**Date:** September 29, 2020  
**To:** Planning Board  
**From:** Dave Sharples, Town Planner  
**Re:** Phillips Exeter Academy PB Case #20-12

**To:** Heather Taylor, Campus Planner/Architect, Phillips Exeter Academy  
Cory Belden, P. E., Altus Engineering, Inc.

The following comments are provided as a follow-up for technical review of the site plans and supporting documents submitted on 8/4/20 for the above-captioned project. (No TRC meeting was scheduled and materials were reviewed independently by Town departments).

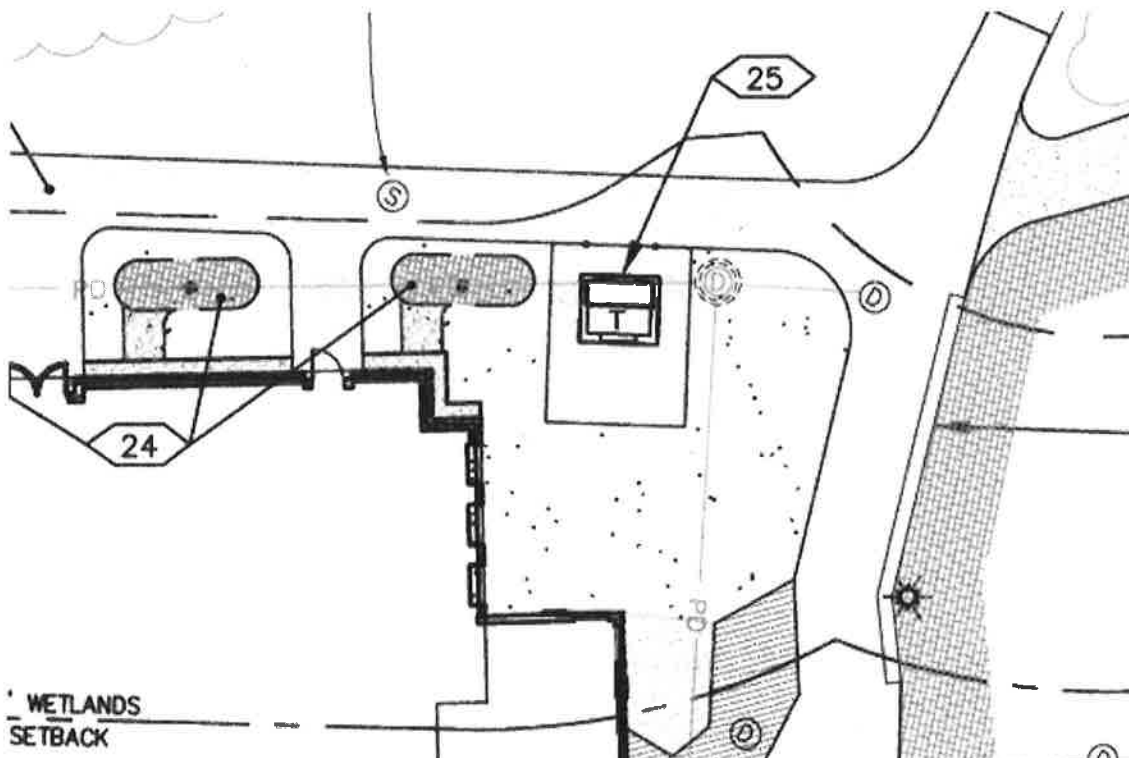
My only comment is that there may be a conflict between the transformer and the proposed drainage line. UEI covered everything else.

I can easily move the MH or T-pad so the drain line isn't under the pad.
